UNITED STATES OF AMERICA  
NUCLEAR REGULATORY COMMISSION

This amendment application consists of Proposed Change Number (PCN)-454 to Facility Operating License No. NPF-10. PCN-454 revises the acceptance criteria for the Agastat time delay relays used in the Engineered Safety Features (ESF) load sequencer in Surveillance Requirement (SR) 3.8.1.18, "A.C. Sources - Operating" of Technical Specification (TS) 3.8.1, "A.C. Sources - Operating." The Bases of SR 3.8.1.18 will also be revised.

DESCRIPTION AND SAFETY ANALYSIS  
OF PROPOSED CHANGE NPF-10/15-454

FIGURE 1

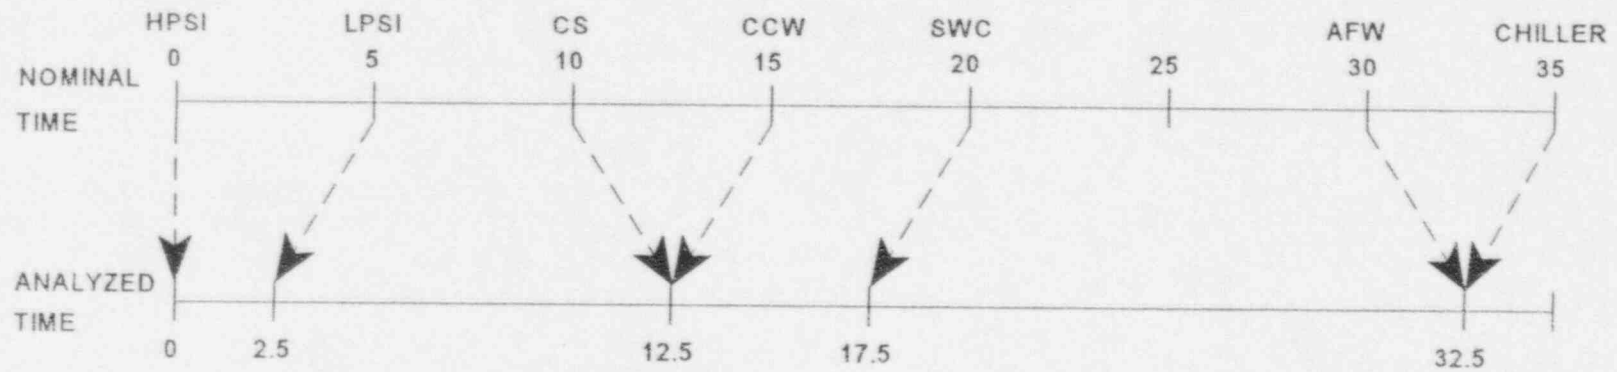
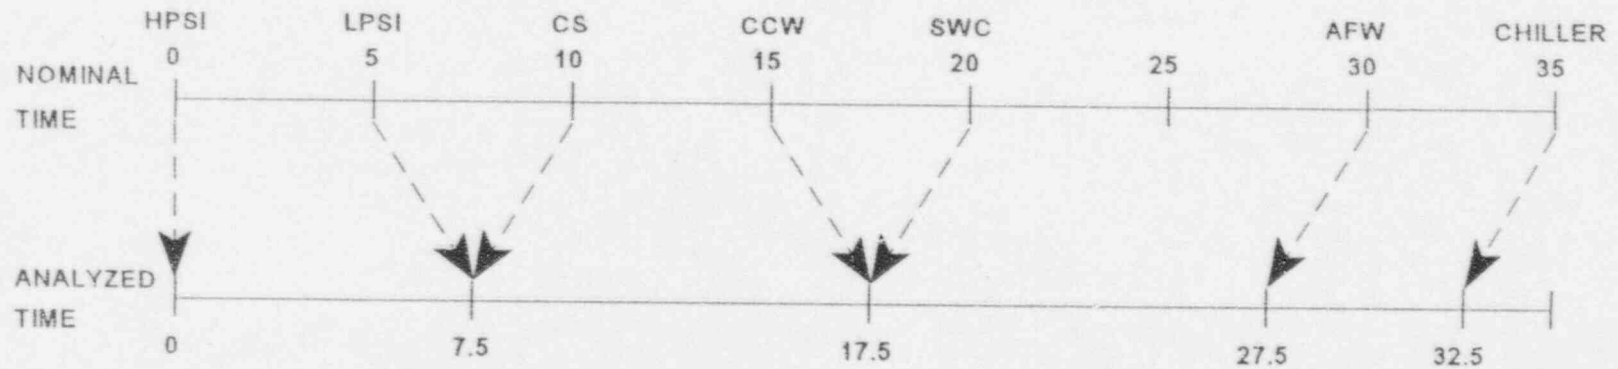
Electrical system performance has been analyzed by performing dynamic voltage analyses assuming a timer tolerance of  $\pm 2.5$  seconds for all load groups. A tolerance of  $\pm 2.5$  seconds creates the possibility of overlap of adjacent load groups (i.e., one load group starts 2.5 seconds late and the following load group starts 2.5 seconds early, resulting in two load groups starting at the same time). Figure 1 illustrates this. All possible combinations of adjacent load groups overlapping have been evaluated and shown to be acceptable with respect to electrical system and DG performance. These analyses are documented in Reference 1 and are included as part of Attachment E.

Although a tolerance of  $\pm 2.5$  seconds for the 5 second load group is acceptable with respect to the loading capability of the DGs, the as-found tolerance for this load group will be -0.5, +2.5 seconds. This ensures that the voltage transient due to starting this load group when powered from the offsite source will not interfere with the Loss of Voltage/Degraded Grid Voltage with SIAS (LOVS/DGVSS) circuitry. The LOVS/DGVSS circuit senses the 4 kV bus voltage just prior to time  $T = 4.5$  seconds and transfers the bus to the DG if the voltage is below the degraded voltage setpoint. If the 5 second load group were to start prior to  $T = 4.5$  seconds, the resulting voltage dip could appear to be a degraded voltage condition, and cause an undesirable actuation of the DVGSS relay scheme. To avoid this potential interference, the as-found tolerance for early starting of the 5 second load group will be restricted to -0.5 seconds. The acceptable as-found tolerance is therefore -0.5, +2.5 seconds.

FIGURE 2

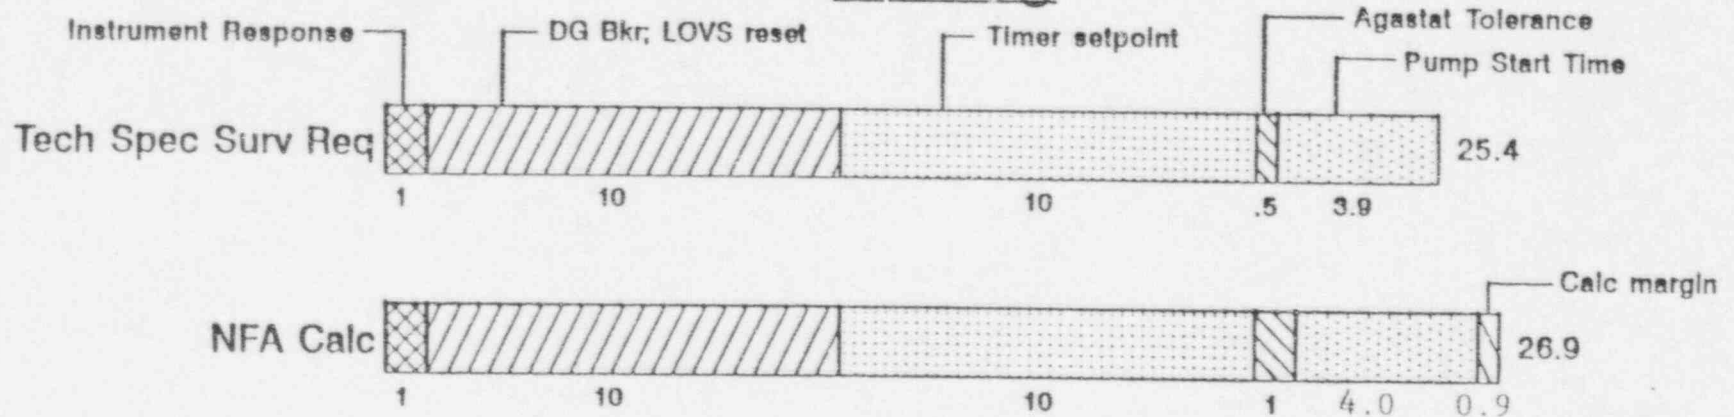
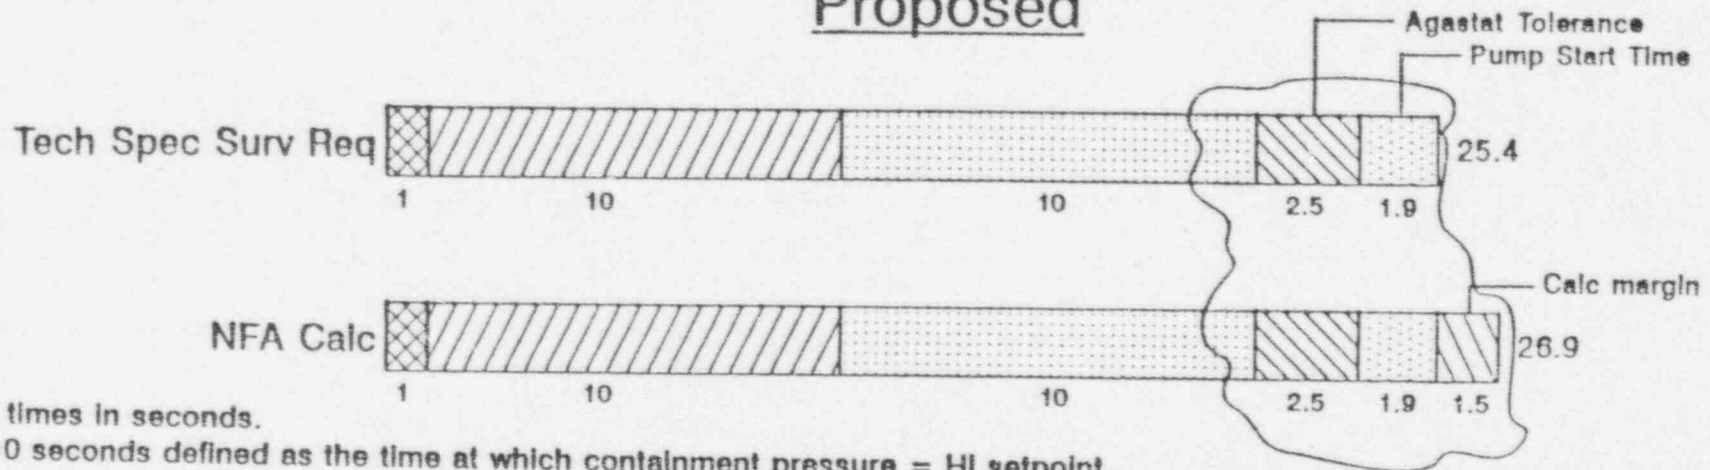
For example, the existing analysis for the Containment Spray system, the most limiting system, demonstrates that an overall system response time of  $\leq 26.9$  seconds is acceptable. This

analysis allocates 1.0 second for timer tolerance, 4.0 seconds for pump acceleration, and includes additional unallocated margin of 0.9 seconds. These intervals can be reallocated as follows with no overall increase to the system response time: 2.5 seconds for timer tolerance, 1.9 seconds for pump acceleration, and 1.5 seconds of unallocated margin. Figure 2 provides this comparison between the Technical Specification required response time for the pump and calculational basis (both existing and proposed) which justifies the changes.

Agastat tolerance can be increased to  $\pm 2.5$  sec. Overall response time is unchanged.
